Different Announcement

Product Multimedia Player Assembly, series model: TR6602/40 is the same as TR3392/40 in DAB function, RAM, RF module, storage capacity, Bluetooth chip, GNSS chip, FM and AM chip and etc. Schematic, circuit design, layout, Hardware version, Software version are different as below detail-

6. Application requirement: adding new model TR6602/40 and this is request a Class II
permissive change for FCC ID: 2AEQTNV101140, granted on 2022-08-04.

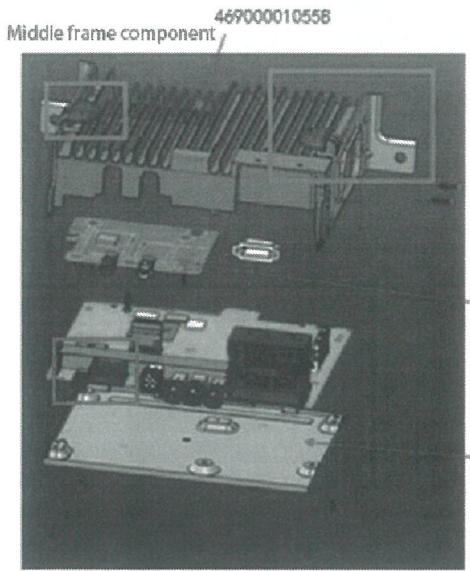
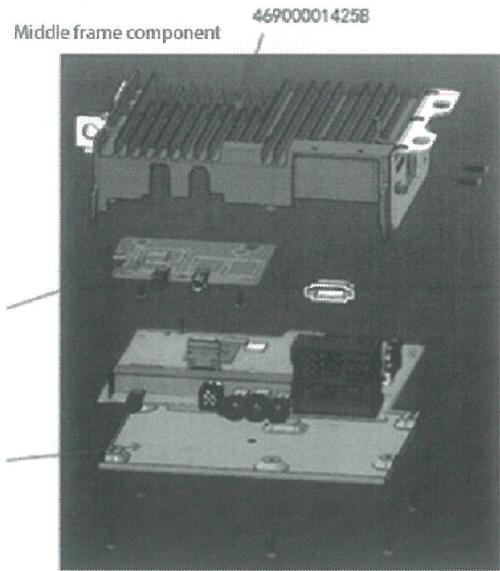
1. The appearance designs of the sample are different as below picture.
2. The functions are different. TR6602/40 has the Ethernet function. The TR3392/40 does not.
3. LVDS chips are different. The TR6602/40 uses DS90UB949, and the TR3392/40 uses MAX96751. The chip is replaced with the same type of chip as pin to pin.
